## **Access Compliance Report Public Rights-of-Way** (Curb Ramps)

Intersection ID: 25298 Main Street: PROVIDENCE RD **Cross Street: WINDBLUFF DR** Location: NW **Severity Score:** ADA ID: D0681C7E8662 Ramp Type: PerpDiag Initial Pass/Fail: Fail **Overall Compliance: No** 22.5

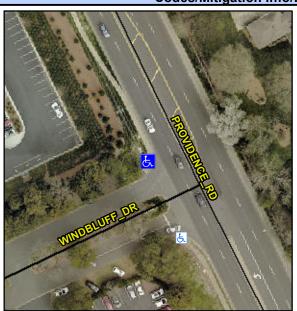
Field Measurements/Component Compliance					
Compliance Description		Data	Comp	liance Description	Data
N/A	Ramp Length (in)	58.0	No	Ramp Slope (%)	9.7
No	Ramp Width (in)	37.0	No	Ramp XSlope (%)	4.6
N/A	Flare Type LT	N/A	N/A	Flare Type RT	N/A
N/A	Flare Slope LT (%)	N/A	N/A	Flare Slope RT (%)	N/A
N/A	Flare Traversable LT?	N/A	N/A	Flare Traversable RT?	N/A
N/A	Landing Length (in)	N/A	N/A	DWS Provided?	N/A
N/A	Landing Width (in)	N/A	N/A	DWS Contrast?	N/A
N/A	Landing Slope (%)	N/A	N/A	DWS Length (in)	N/A
N/A	Landing X Slope (%)	N/A	N/A	DWS Full Width?	N/A
N/A	Landing Curb? (Y/N)	N/A	N/A	DWS Offset (in)	N/A
N/A	Shared Landing?	N/A			
N/A	Gutter Ponding?	N/A	N/A	Gutter Slope (%)	N/A
N/A	Gutter Lip Ht (in)	N/A	N/A	Gutter X Slope (%)	N/A
N/A	Painted X Walk1?	No	N/A	Painted X Walk2?	No
	X Walk 1 Direction	To S		X Walk 2 Direction	То Е
N/A	X Walk 1 Width (in)	N/A	N/A	X Walk 2 Width (in)	N/A
	X Walk 1 Slope (%)	0.5		X Walk 2 Slope (%)	5.3

X Walk 1 X Slope (%)	5.8		X Walk 2 X Slope (%)	0.2
N/A	Ramp inside XWalk1?	N/A	N/A	Ramp inside XWalk2?	N/A
	Road Slope (%)	3.8	N/A	Clear Space?	N/A
	Road X Slope (%)	6.9	N/A	Clear Space to XWalk (in)	N/A
N/A	Any Obstructions?	N/A	N/A	Storm Grate/Utility Hazard?	N/A
	Obstruction Type			Storm Grate/Utility Type	
		N/A			N/A
			Yes	Surface Condition? (G/P)	Good

Possible Solutions: Remove & Replace Curb Ramp With Two New Directional Ramps or Equivalent. Surveyor Notes: N/A PROW/ADA: R304.5.1, R304.2.2, R304.5.3
